**SUBDIVISION &
ZONING AMENDMENT STAFF REPORT****Date: February 16, 2017****APPLICANT NAME**

USA Springhill East Subdivision

Northeast corner of Spring Hill Avenue and North Lafayette Street

PROPOSED SITE PLAN

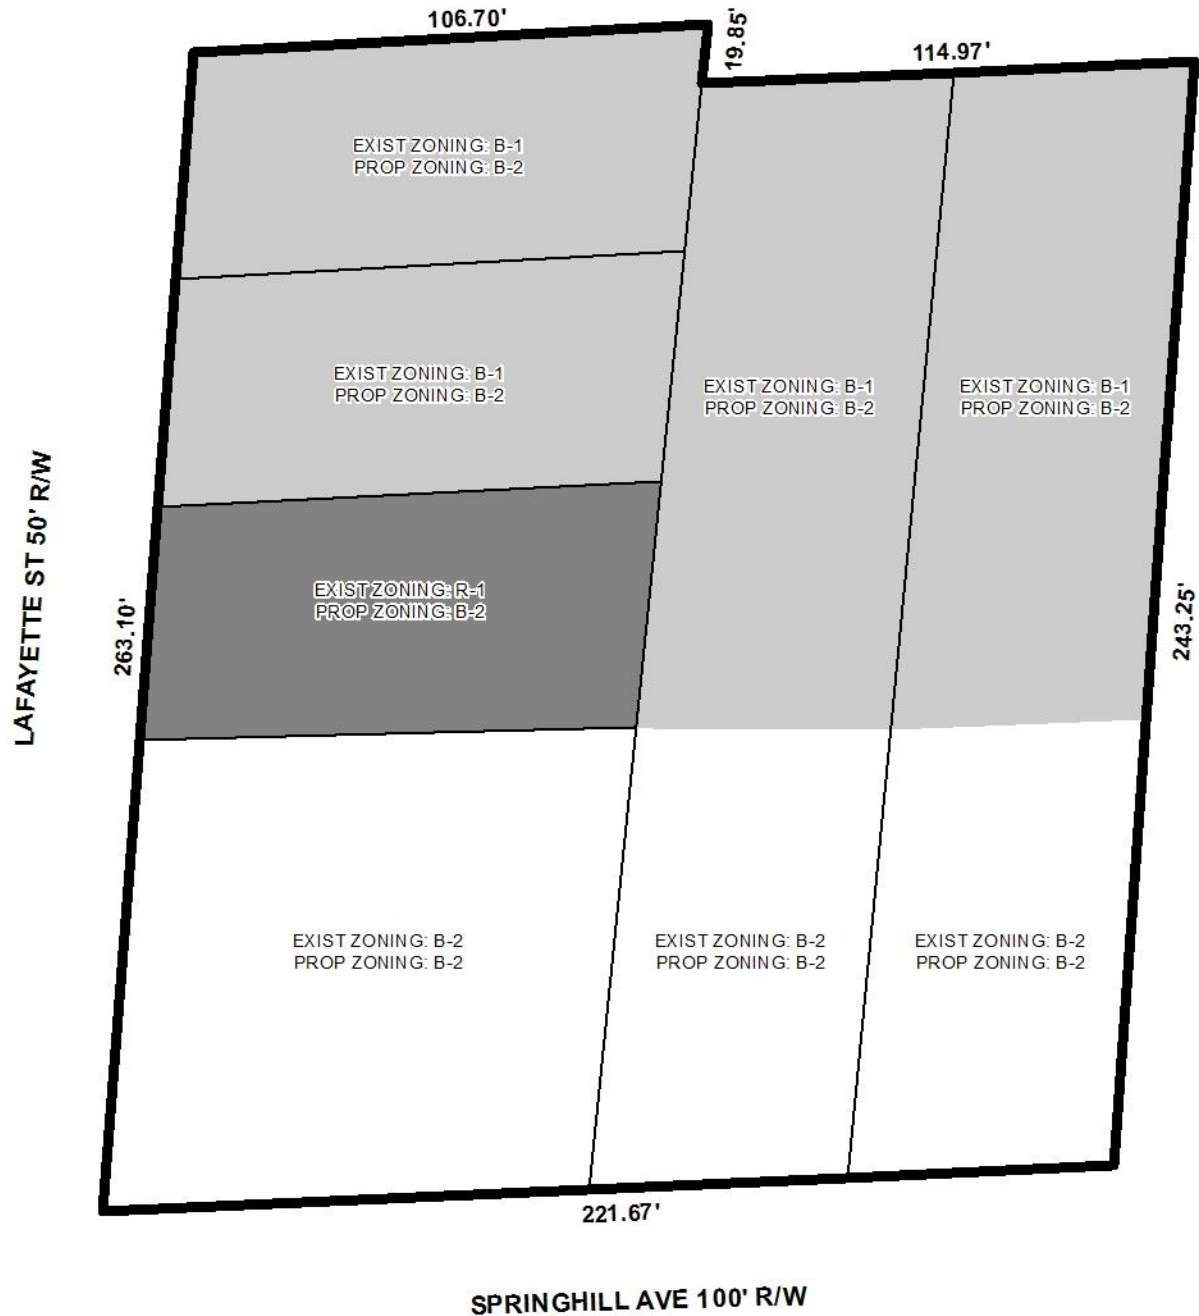
The applicant states that the site has an existing 40' x 70' structure and asphalt parking that will be demolished for the re-development of a Fresenius medical clinic. A proposed site plan depicts a new 6,968 square foot nephrology clinic, dumpster, and all required parking, access, and maneuvering areas to be on the subject site. It should be noted that rezonings are not site plan specific, so if the existing shared access to the property to the North is to be maintained, an Administrative Planned Unit Development application will be required prior to re-development.

The proposed site plan indicates that a dumpster will be provided on the site. It should be noted that the dumpster will be required to be connected to sanitary sewer as well as have a dumpster enclosure compliant with Section 64-4.D.9. of the Zoning Ordinance.

The proposed 6,968 square foot clinic would require 24 parking spaces, and is illustrated to have 35 parking spaces, and will therefore require photometrics to be submitted at the time of permitting. All proposed access and maneuvering areas are 24' wide to allow two-way travel, with the exception of a 15' wide drive in the front of the building which appears to be for a patient drop-off area. Any access and maneuvering areas less than 24' wide should be clearly indicated as one-way traffic.

The proposed site plan indicates several large existing trees in the right-of-way adjacent to the site. The canopy of these trees should be illustrated at the time of permitting so that frontage tree requirements will be appropriately reduced to allow the existing trees room to continue to thrive.
